From: Marissa Houlberg <marissa@houlbergdevelopment.com>
Sent: Monday, December 14, 2020 1:57 PM
To: Engineering External Email <engineering@tualatin.gov>
Subject: 2019 Stormwater Master Plan questions and thoughts

For Public Record- Proposed Update to City of Tualatin Stormwater Management Master Plan

RE: Proposed Update to City of Tualatin Stormwater Management Master Plan

LEA Comments
On the Draft Tualatin Stormwater Master Plan
(Dated April 2019)

An example of questionable information provided within many maps within the proposed Stormwater Management Plan for the City, is **Figure 2-2 Project Area Overview**.

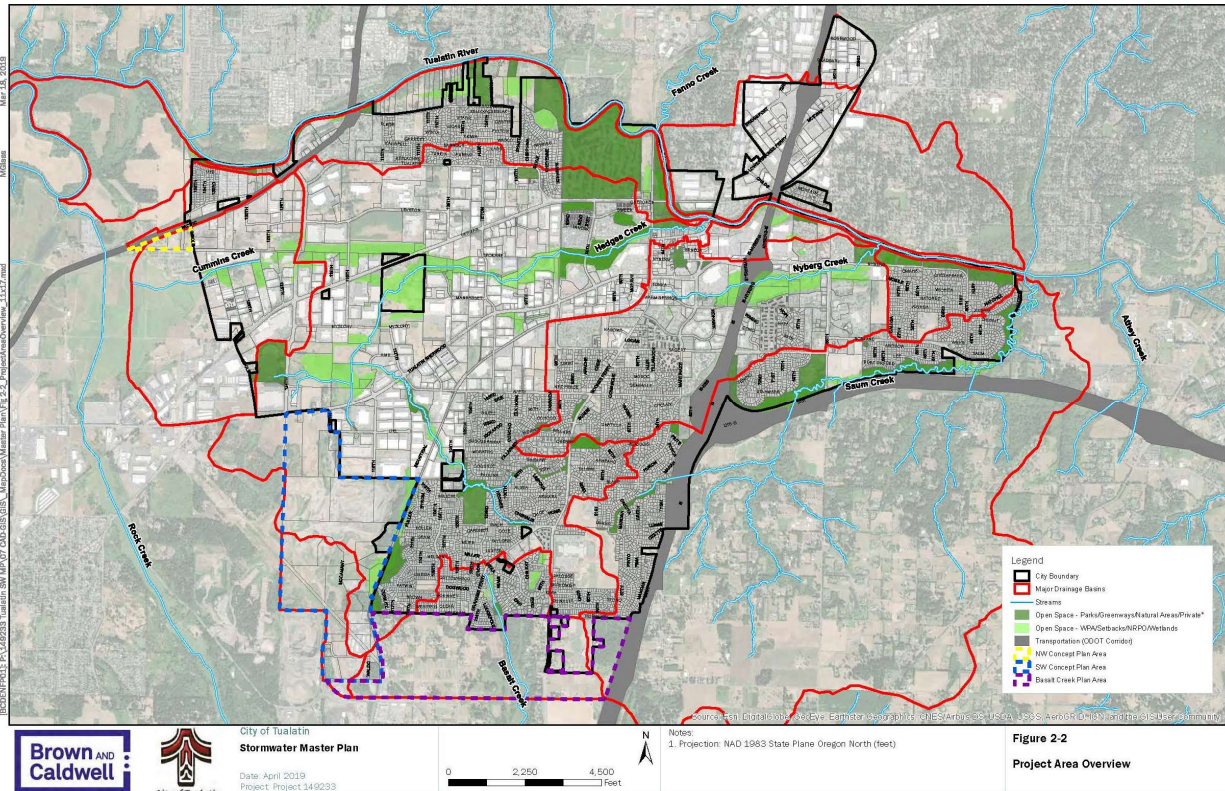
Another factor not denoted within the maps within proposed Stormwater Management Plan, is the identification of the "Natural Area" within the Basalt Creek Canyon.

This area which contains wetlands and various Natural Resources requiring conservation and protection was identified within the Basalt Creek Concept Plan in which both Cities agreed to have "joint management" of the "Natural Area". It would seem reasonable this information which might impact Land Use Planning within the Basalt Creek Area and is downstream from the Basalt Creek lands already annexed into the City, would be identified on the Figure 2-2 map, and include additional information within the narrative of the proposed Stormwater Management Plan as a potential constraint or limitation in the planning of Stormwater Management in the area or upstream from the "Natural Area".

This map also includes the notation of "Brown and Caldwell City of Tualatin Stormwater Master Plan Date: April 2019 Project 149233" in the lower left corner of the map. An assumption would be that the information provided within this map would be current and accurate as of April 2019- the date indicated on the lower left corner of the map. It is unknown how current the information contained within this map may be but lacking the inclusion of information Basalt Creek Area lands already within the City's boundaries, makes one question when the data for this map was last collected.

Figure 2-4 "Land Use" Map Not Consistent with City's Current Land Use Zoning

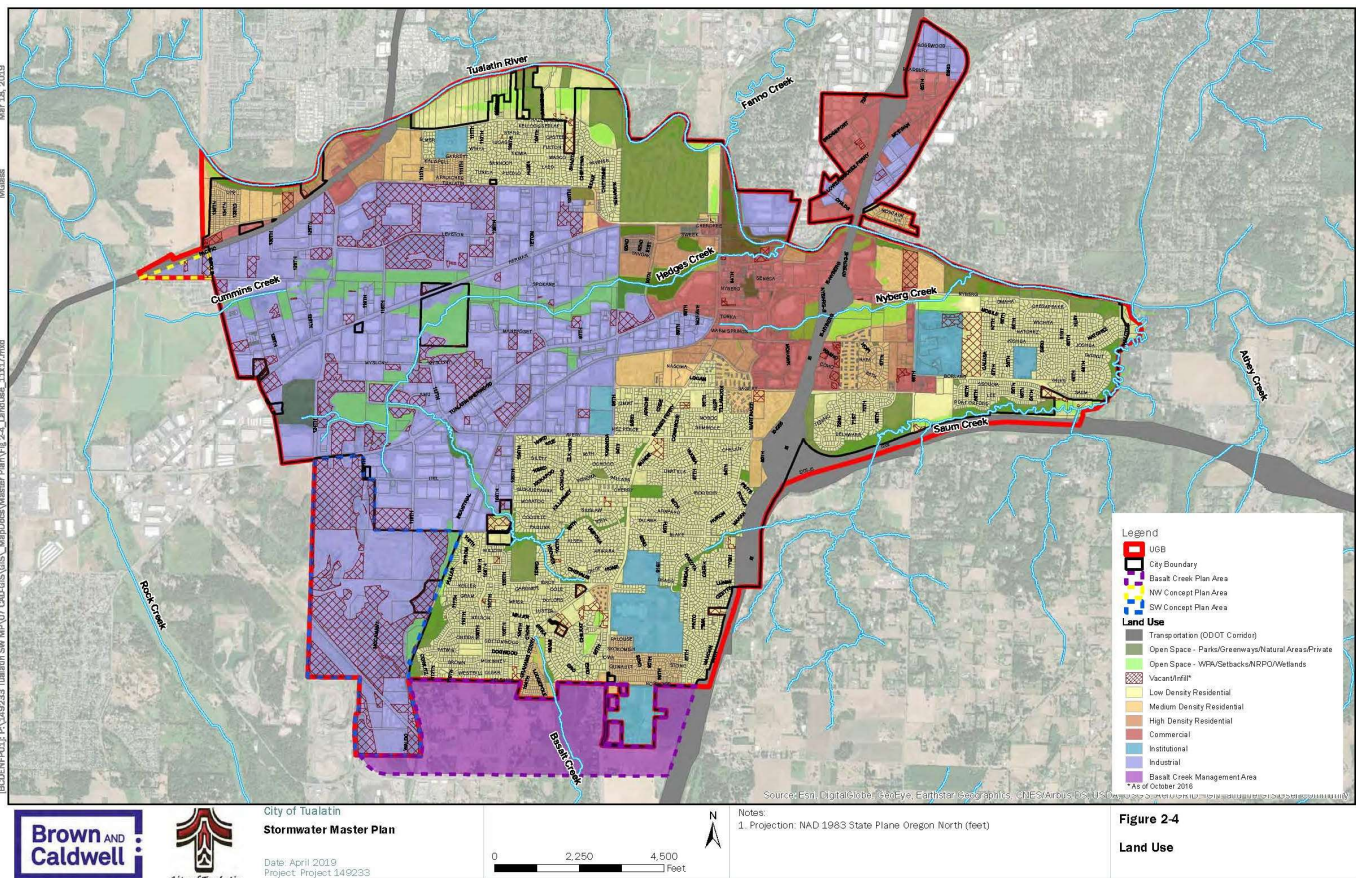
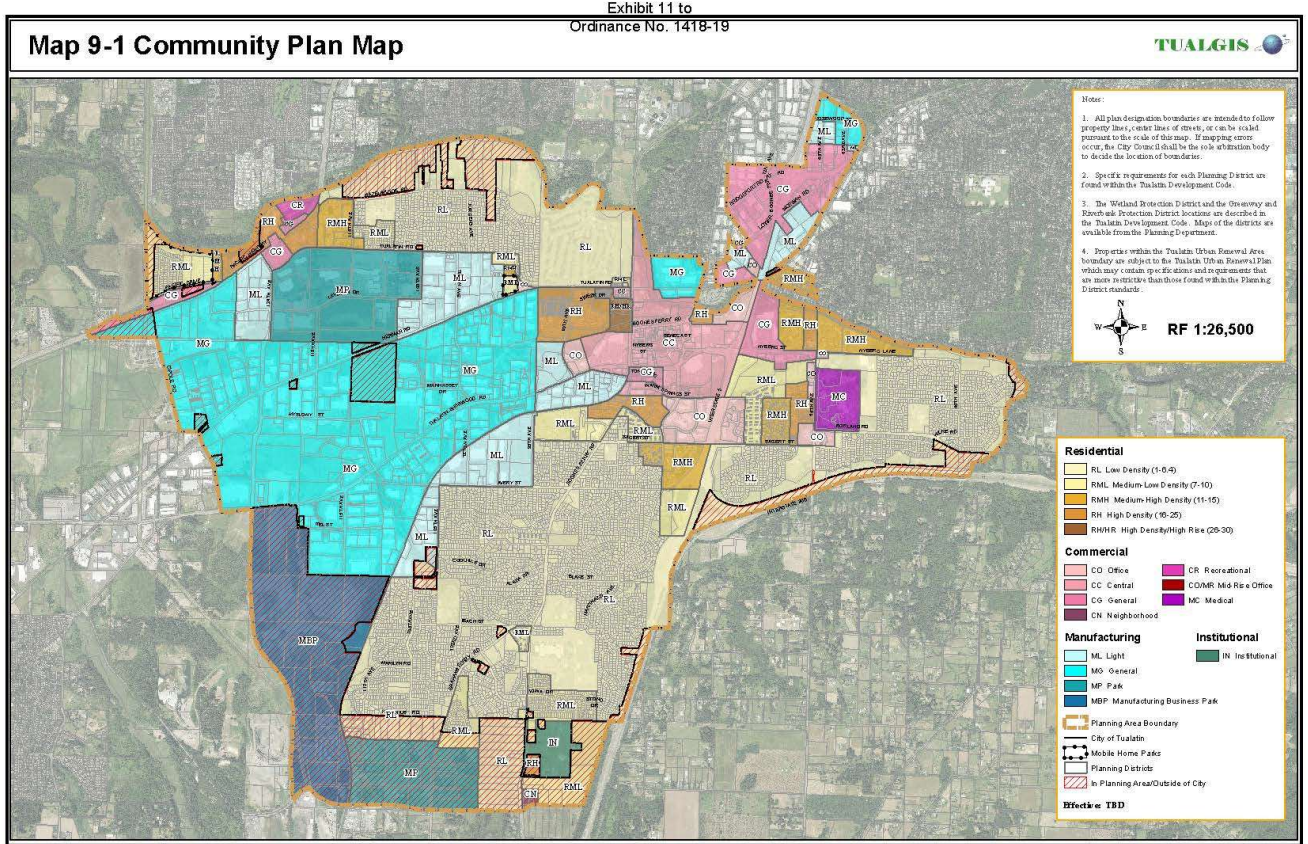
also provides the notation of "Brown and Caldwell City of Tualatin Stormwater Master Plan Date: April 2019 Project 149233 in the lower left corner of the map.

Yet, an asterisk notation within the Legend box states, "* As of October 2016".

Major changes have occurred as to Land Use within the City of Tualatin in the four years since this map was apparently generated.

The information provided as to the Land Use zoning or designations do not accurately reflect the Land Use Planning Actions of the Basalt Creek Concept Plan adopted in 2018, nor the City of Tualatin Basalt Creek Comprehensive Plan. Land Use Zoning within the Basalt Creek Area does not provide accurate information of current Land Use Zoning and Planning within the Basalt Creek Area and may hinder the planning for Stormwater Management in the assessment of current and future needs based upon type of land use. Approximately 60 acres within the Basalt Creek Area have already been annexed into the City of Tualatin, and into the responsibilities and regulations of the City for Land Use planning- including Stormwater Management.

The proposed Stormwater Master Plan Update is not consistent with the Land Use Plan adopted by the City in 2019 in Ordinance 1418-19, and consequently would not be compliant with Statewide Planning Goal #2

72-1 Natural Resources Protection Overlay district (NRPO) and Greenway Locations

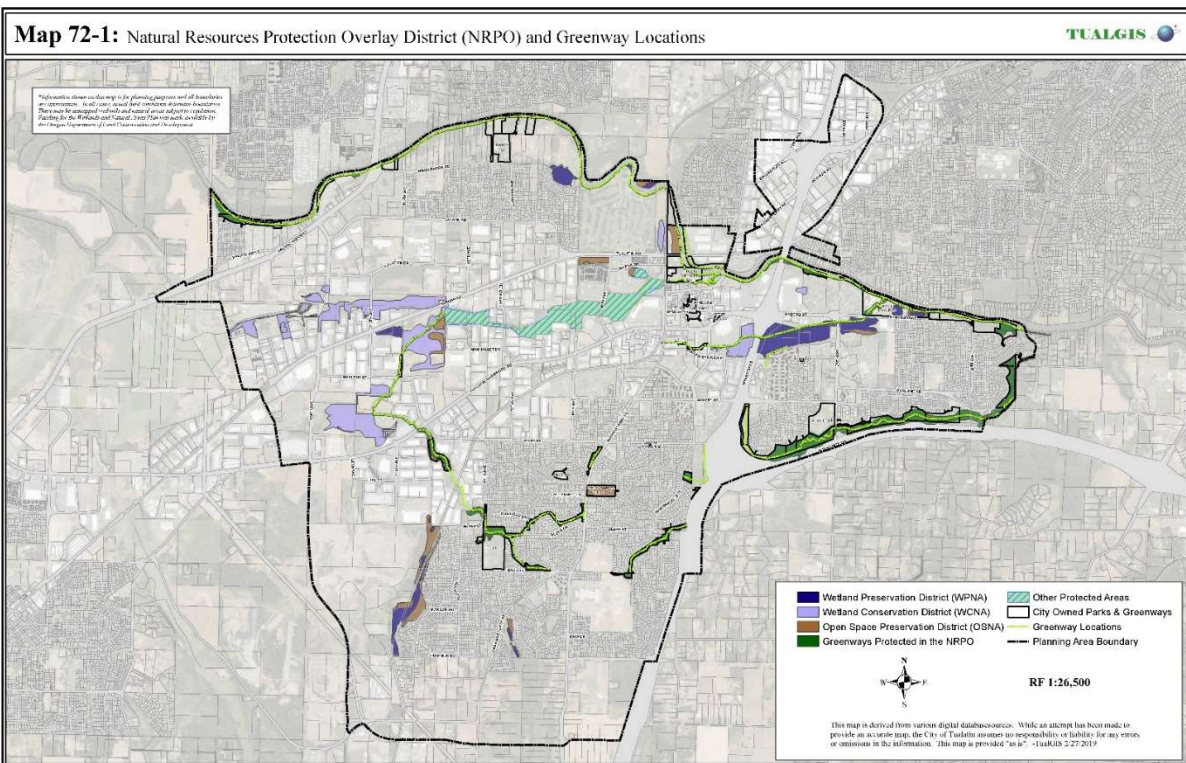
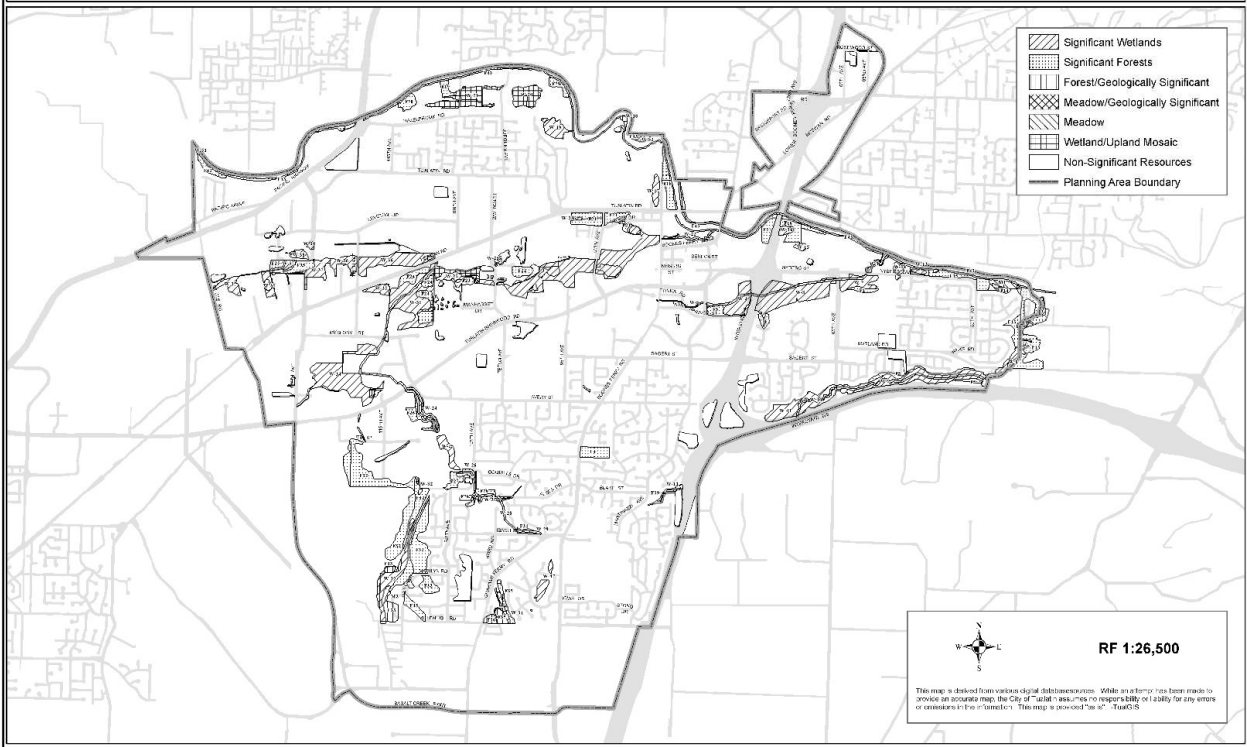
There is an absence of necessary information provided for the Basalt Creek Area for Natural Resources

Lacking necessary evaluations as to the level, location and quality of Natural Resources within the Basalt Creek Area within the proposed Stormwater Management Master Plan Update, it would be difficult for the City of Tualatin to utilize the maps adopted into the City's Governing Documents (as part of the adoption of the Basalt Creek Comprehensive (Ord. [1427-19](#), § 47, 11-25-19)), as supportive or back up documents to the proposed Update, as these maps obtained from the City's website do not identify or provide substantive information as to the multiple Natural Resources which are known to exist within the Basalt Creek Area.

Figure 13 Natural Resources Map

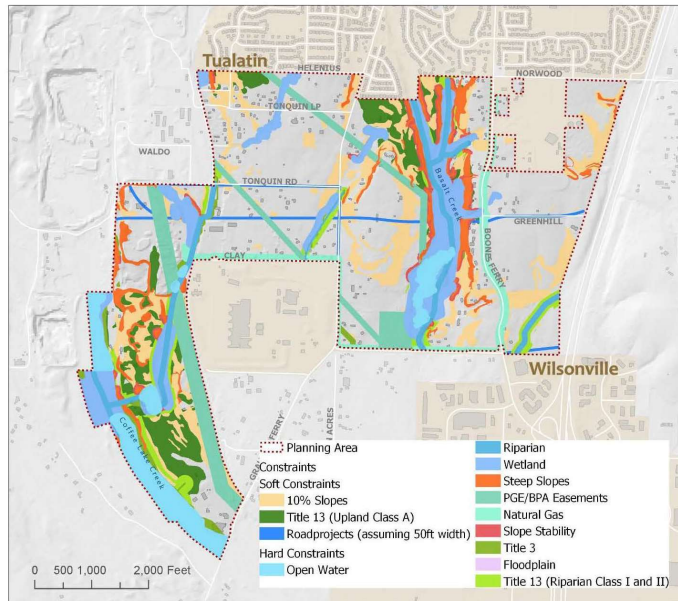
It is unclear as to the rationale for the omission of pertinent information required to be an evaluated component in the development of all Land Use Plans and implementation of Planning Actions have not been included within the proposed Stormwater Master Plan Update, nor in the City's Governing Documents as provided via the City's
